Our Ref: 18.037

22 July 2020

Re: Site Compatibility Certificate – 7 Walker Crescent, Raymond Terrace

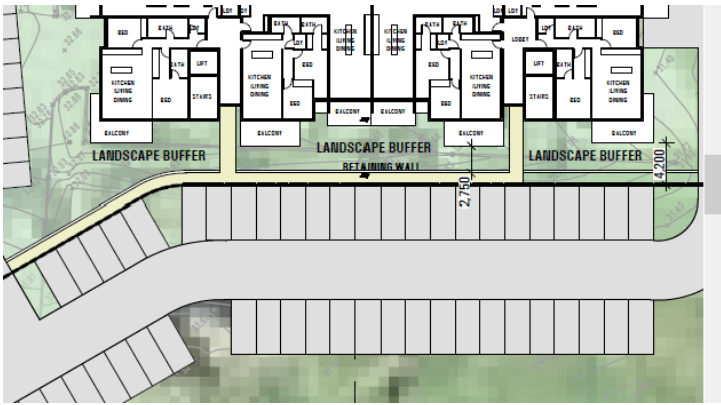
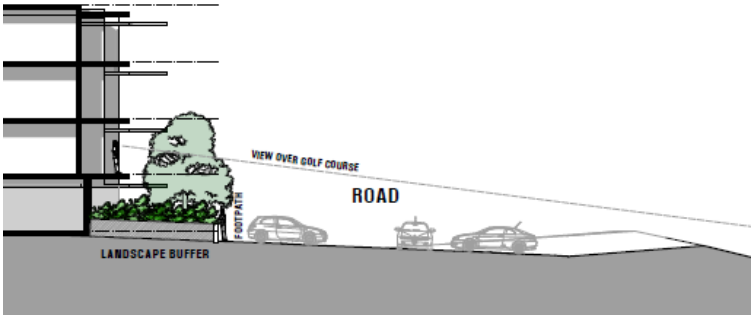
Panel Recommendation	Client response as a result of detailed design
1	Block A to be reduced in scale by one (1) storey	<p>Given the Panel's concern on this matter related to privacy and overlooking, the attached plans now clearly show the following:</p> <ul style="list-style-type: none"> • Internal layouts designed to Development Application level with no 'active' rooms directly overlooking the adjoining property to the north. Bedrooms have instead been positioned along the north face. • Type A units have deep planter boxes along the boundary edge. This prohibits unit residents overlooking the northern neighbourhood properties. • The plans clearly indicate where the existing vegetation is located and, importantly, the size of those trees. • Building setbacks from the northern boundary have been confirmed at 16m. Additional dense landscaping can be accommodated within this setback as part of any Development Application. This would include a high number of canopy trees suited to this locale.  <p>Figure 1 Floorplan layout Building 1</p> <p>It is considered the combination of the substantial building setback, the reconfiguration of internal areas so that no 'active' rooms face the northern boundary, and the presence of the existing substantial vegetation on the boundary, would provide an appropriate amount of separation between the development and adjoining properties to the north, ensuring their privacy and amenity was maintained.</p> <p>It is noted that Building 2 has been lowered and moved towards Walker Crescent and reduced its bulk form when viewed from the street and to provide an address to that street. Detailed landscaping of this setback, including pathways, letterboxes and the like, can be provided at the time of a Development Application.</p> <p>The fourth level on Buildings 3, 4, 5 and 6 has been deleted. There is a total reduction of eight (8) apartments across the proposed development.</p>

Figure 4 Building 2 layout as per SCC considered by Panel

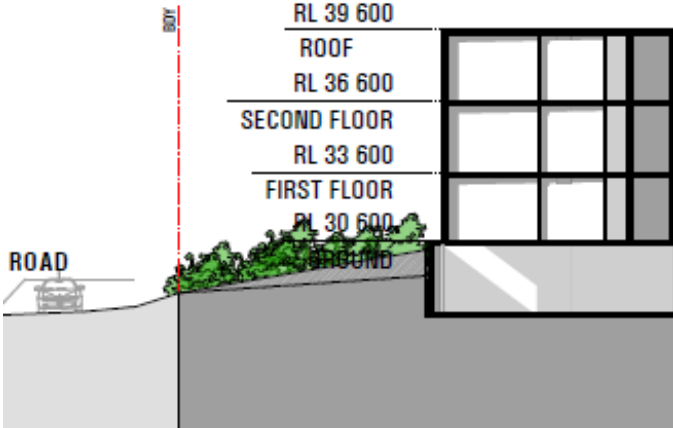
3	<p>Block B is to provide an address to Walker Crescent. Block B is to be reduced by one (1) storey.</p>	<p>Building 2 has been redesigned providing for a partially excavated car park which in turn reduces the height of Building 2, providing apartments with a ground level address to Walker Crescent.</p>

Figure 4 shows the layout of Building 2 as lodged originally. In that scheme the setback from the northern boundary was only 4.65m, and 7.7m from Walker Crescent. At grade parking was proposed.

Figure 5 shows the layout of Building 2 in response to the Panel's comments. Amendments include completely relocating the building to the southwest which has resulted in increased setbacks of 8m to the north, and 11m to Walker Crescent. It has also prompted a reconfiguration of the golf course entry road. Importantly, the building has been lowered into the sloping ground to 'sink' the parking, and to improve the interface with Walker Crescent.
